DOCKET NO. 50-400/LICENSE NO. NPF-63
REQUEST FOR LICENSE AMENDMENT
TECHNICAL SPECIFICATION 3.7.5a

SHEARON HARRIS NUCLEAR POWER PLANT, UNIT NO. 1
DOCKET NO. 50-400/LICENSE NO. NPF-63
REQUEST FOR LICENSE AMENDMENT
EVALUATION OF PROPOSED CHANGES

Subject: Request for License Amendment of Technical Specification 3.7.5a,
"Ultimate Heat Sink" to recover margin in Main Reservoir minimum
allowed level

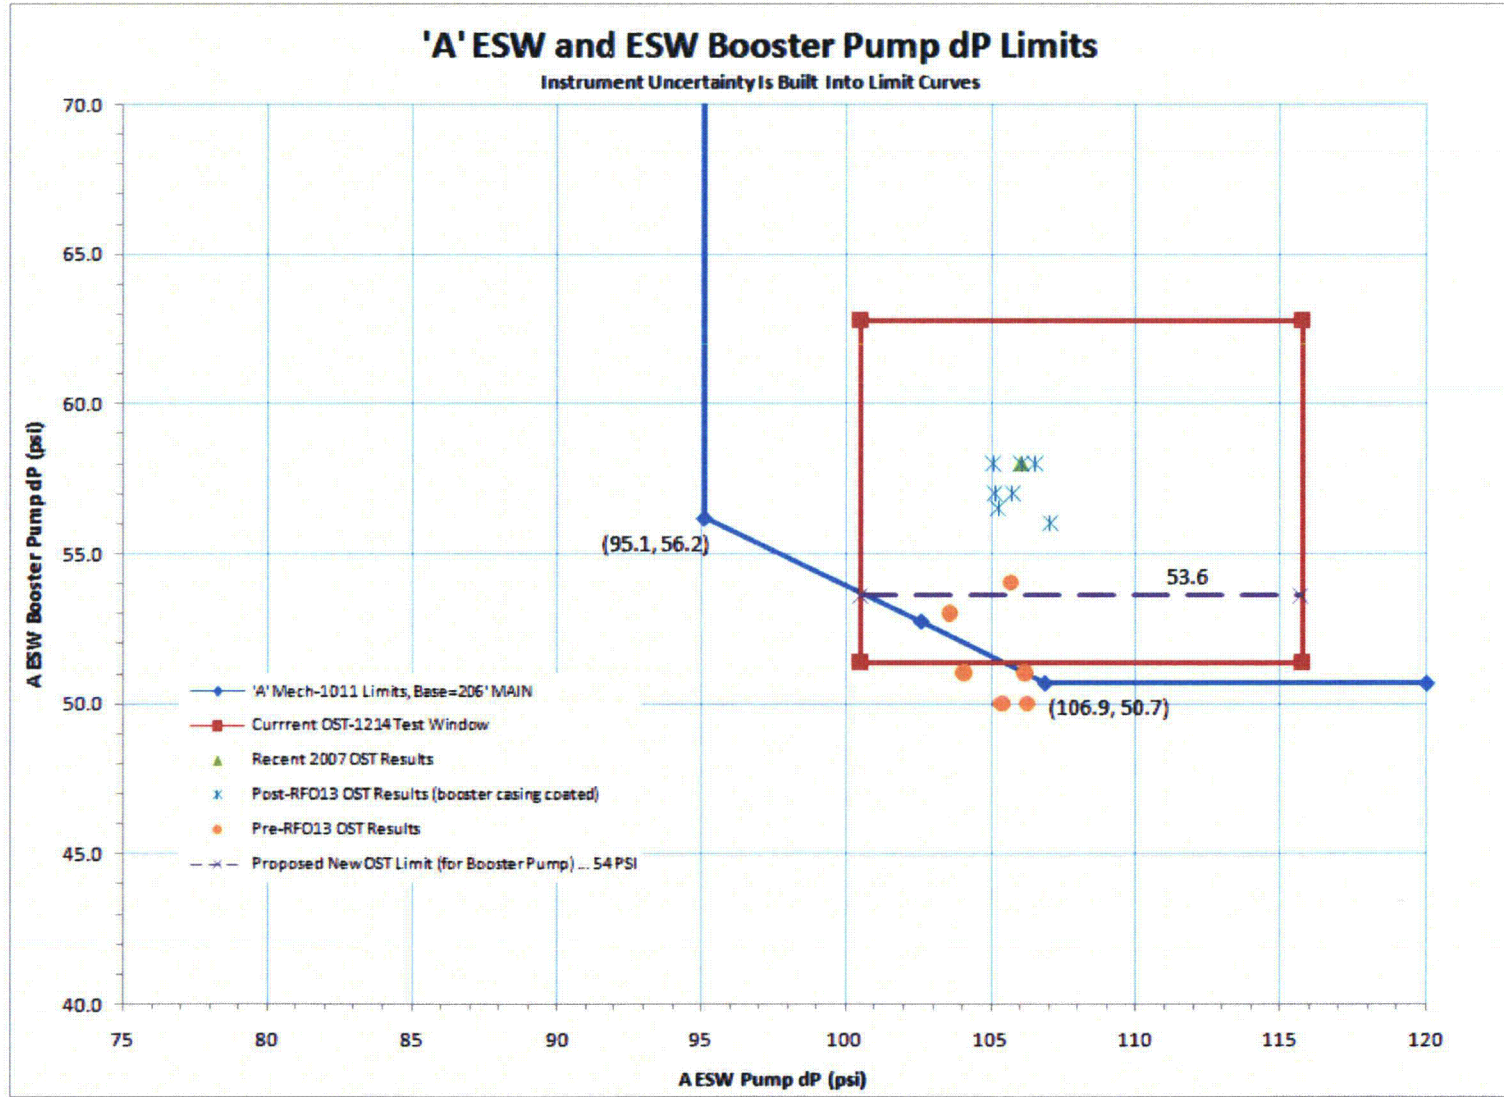
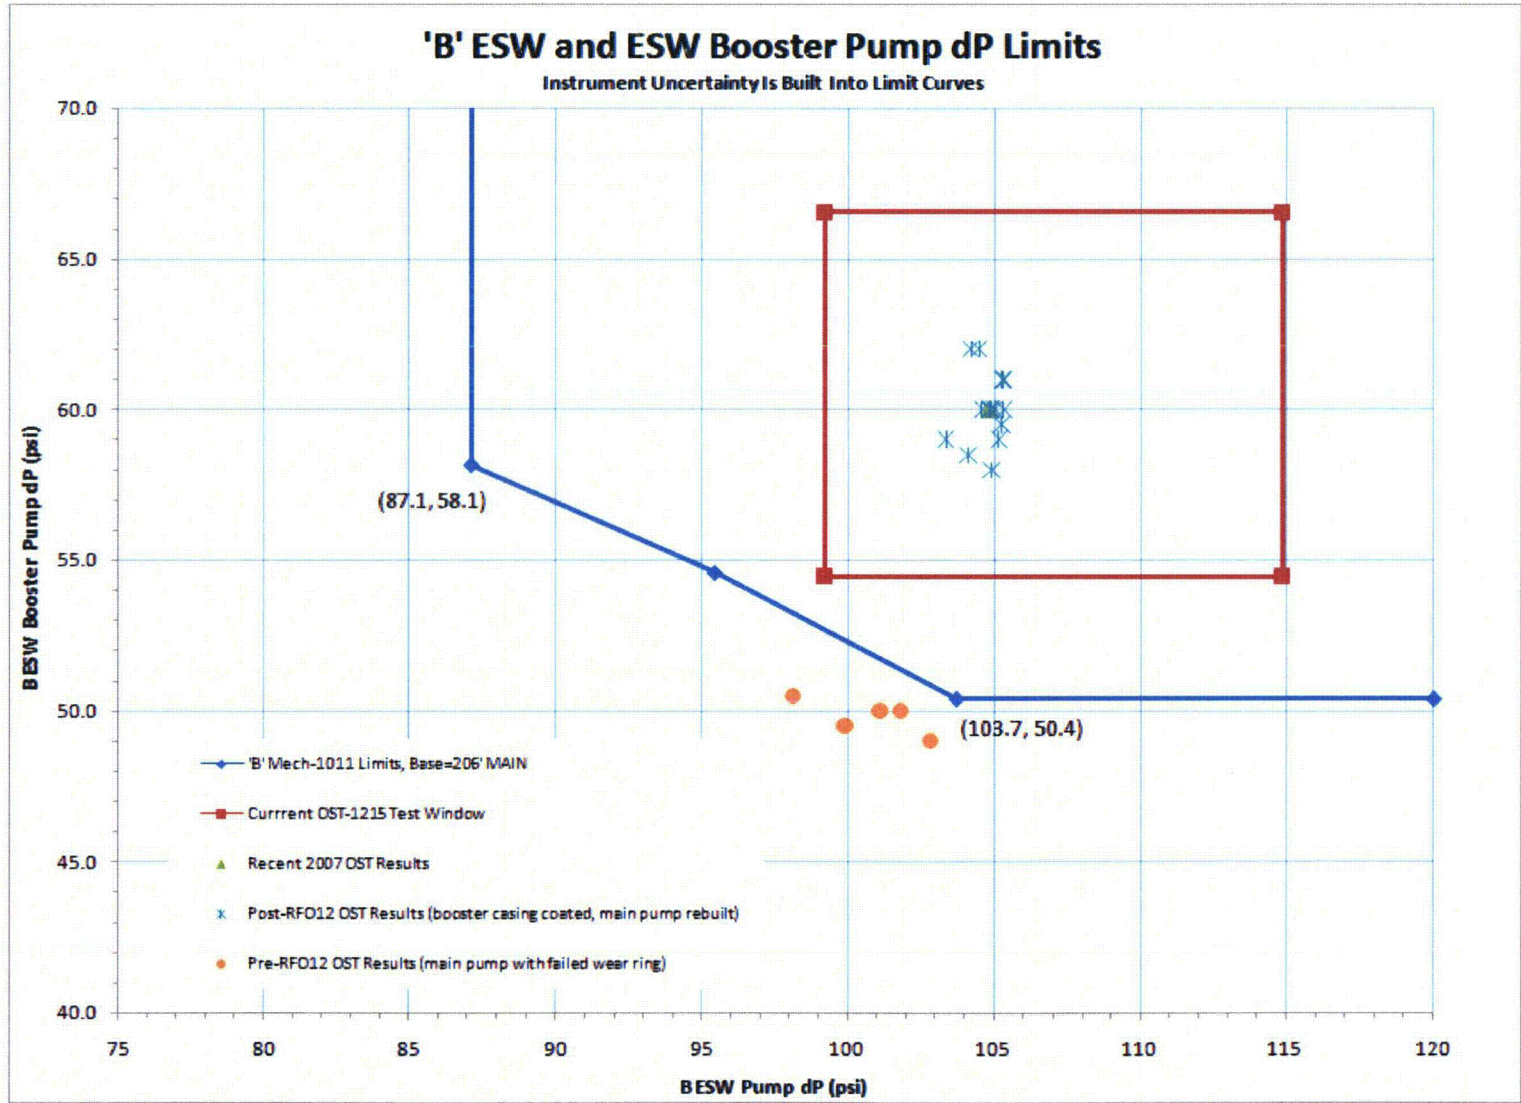
Since the ESW Pumps and ESW Booster Pumps both contribute to ESW pressure inside containment, HNP-M/MECH-1011 provides the minimum allowable pump differential pressures (dP) for both pumps for each train on a single graph. This allows for various combinations of limits between the ESW and ESW Booster Pumps. It also graphs the current Operations Surveillance Test (OST) limits and some recent and historical OST data against the new pump dP limits. These graphs are shown on pages 10 and 11 of Enclosure 1.

From the graphs, it can be seen that recent OST results are all greater than the proposed pump dP limits. This data indicates that the pumps are not likely to challenge the new limits in the near future. The graphs also show that current 'A' train OST limits are truncated by the new limits. As a result, OST-1214 (ESW System Operability, Train A) will need to be revised. HNP intends to raise the minimum allowable pump dP for the 'A' Booster Pump to 53.6 PSID without changing existing 'A' ESW Pump limits. All 'B' train OST-1215 (ESW System Operability, Train B) limits (ESW Pump and ESW Booster Pump) remain unaffected.

As noted in Section 4.2, the minimum OST-1214 differential pressure limit for the 'A' ESW Booster Pump will need to be increased to 53.6 PSID. Recent OST data shows that 'A' ESW Booster Pump should continue to remain above this new minimum limit. No changes are required for the 'A' ESW Pump limits.
